Permit Number: 090687

This is to certify that DIRSA ANGELA E & THOMAS CHANSON Charles B. M...  
has permission to Build additional Bay onto existing Garage, build main Suite over Garage. Reconfigure the Interior of the existi  
on Second Floor  
AT 20 LEDGEWOOD DR CB... 415 A013001

**City of Portland, Maine - Building or Use Permit Application**  
 389 Congress Street, 04101 Tel: (207) 874-8703, Fax: (207) 874-8716

DESIGN OF :  
**GARAGE & MASTER BEDROOM**

EXISTING CONDITION PLAN OF LAND  
IN  
**PORTLAND  
MAINE**

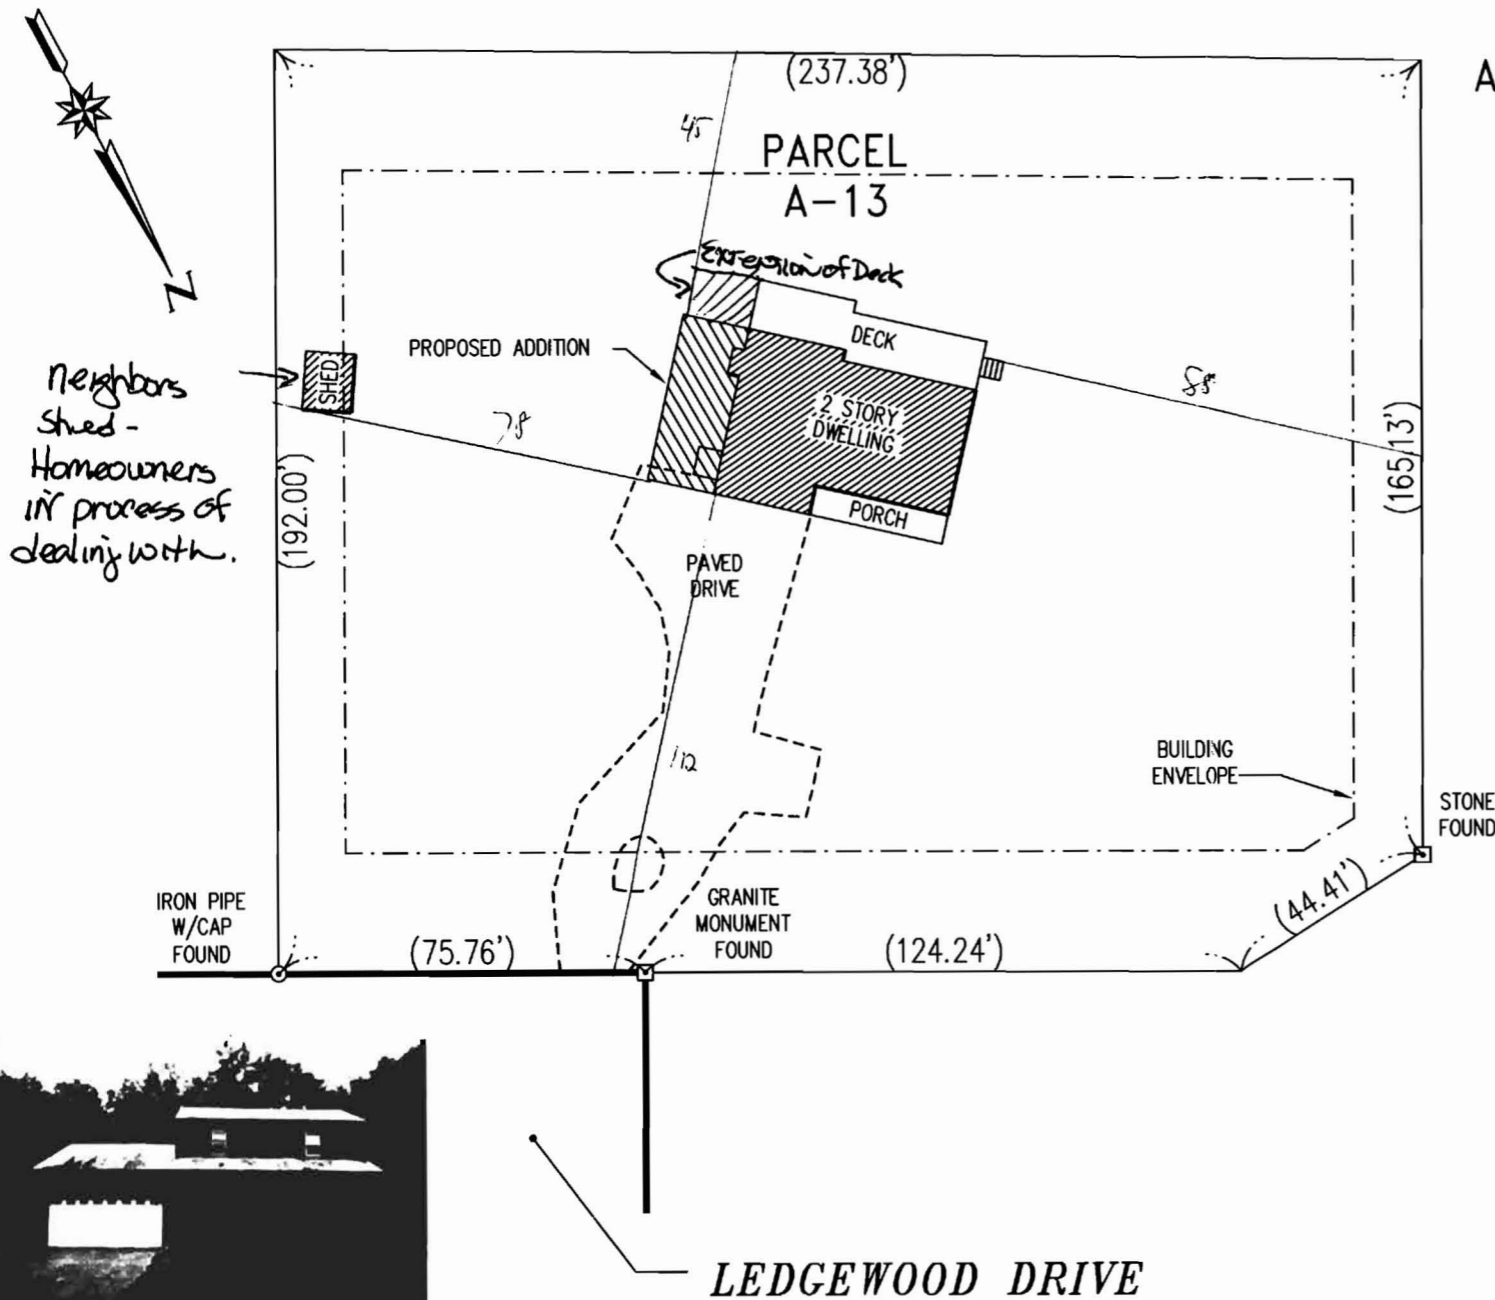
**Comments:**  
 7/6/2009-amachado: Left vcm for Chuck Messer, contractor. Plot plan shows rear deck also being expanded but the building plans don't. Chuck dropped off a sketch for the addition of the deck (11' x 14').

*Neighbors  
Shed -  
Homeowners  
in process of  
dealing with.*

REAR ELEVATION  
SCALE 1/4" = 1'-0"

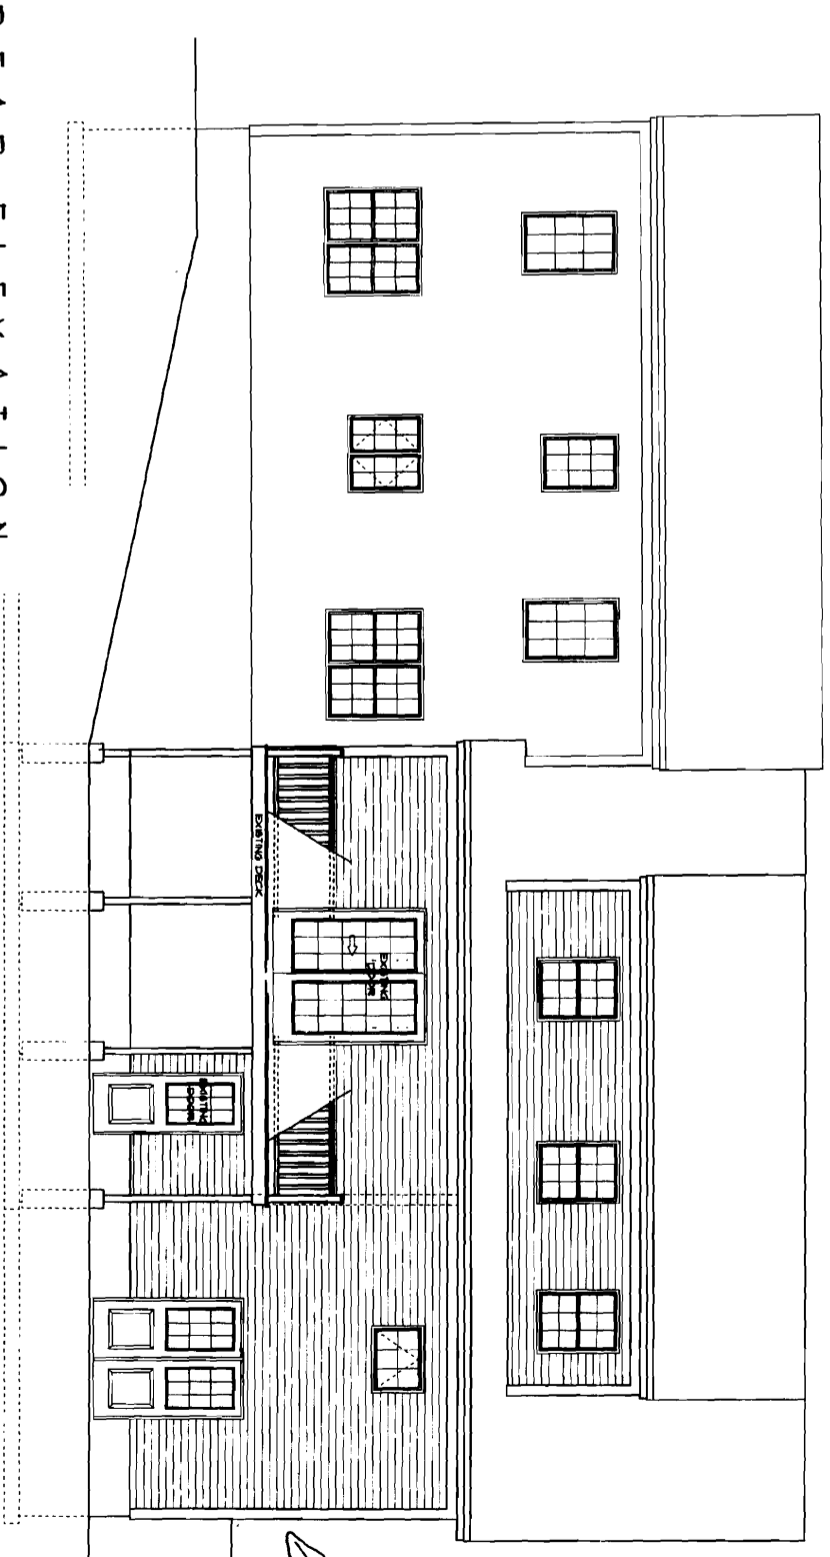
needed  
extended  
See plan  
revised 7/11

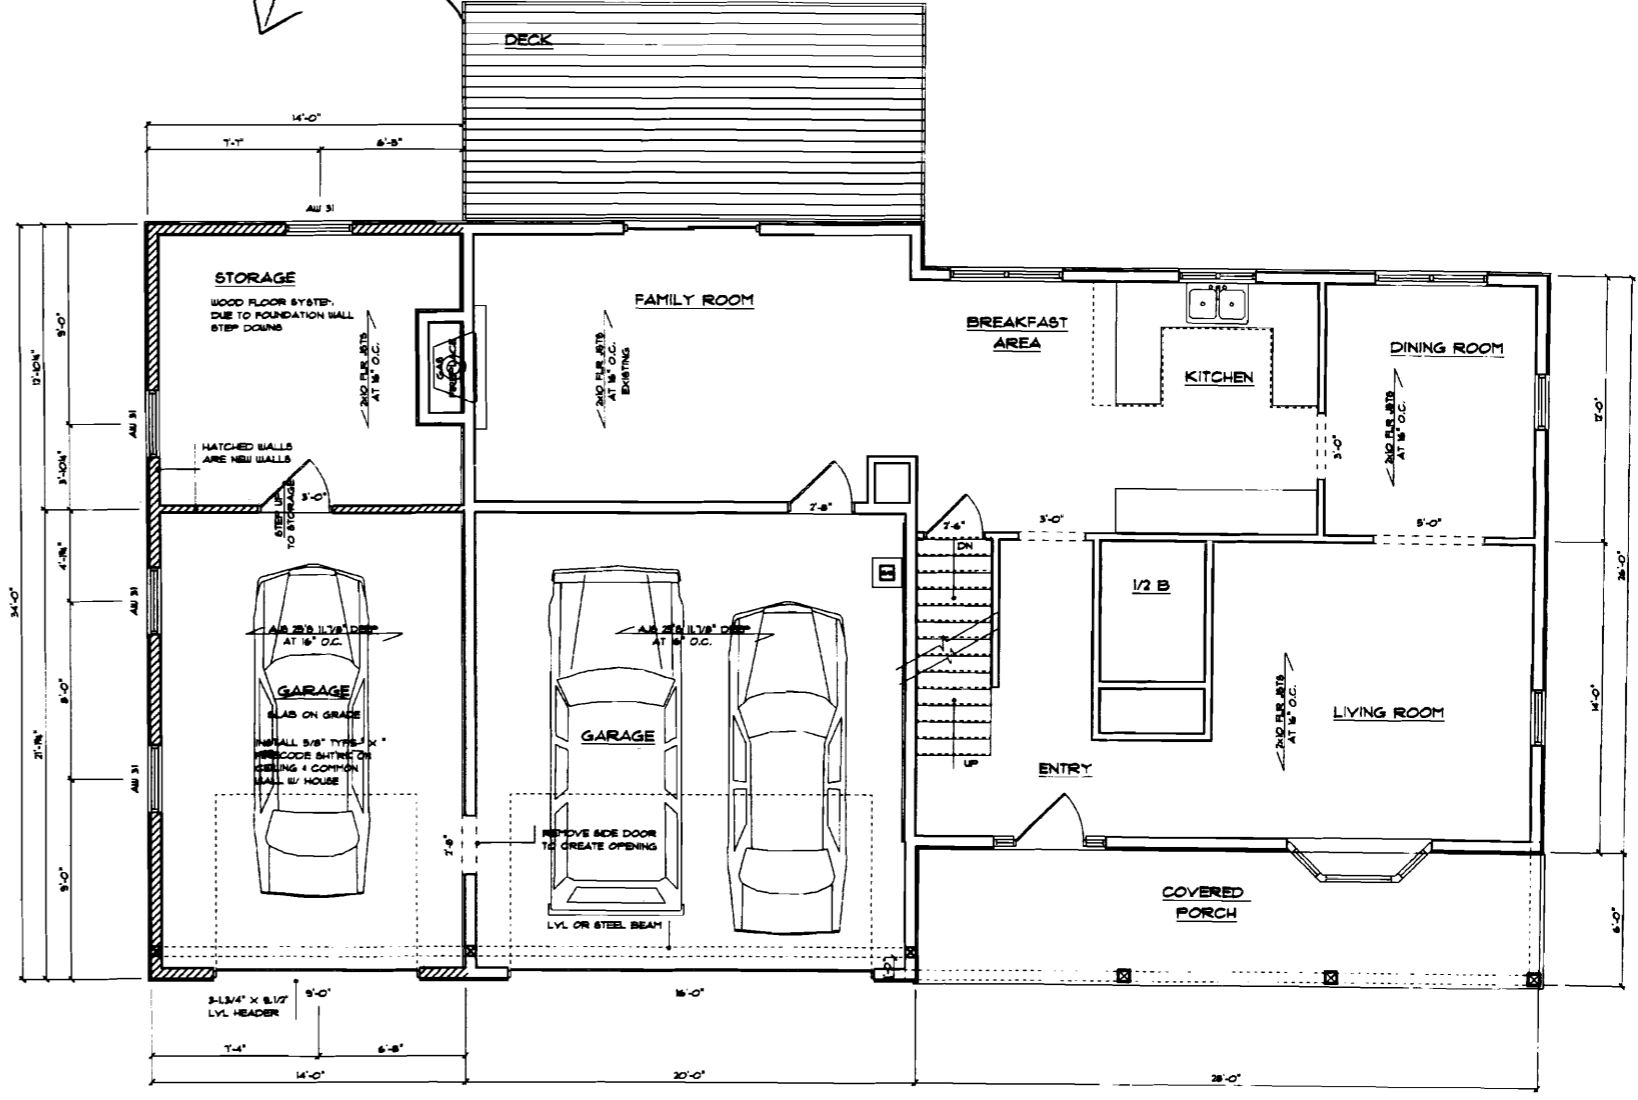
*Extend deck to end of addition per sketch submitted 7/6/09*
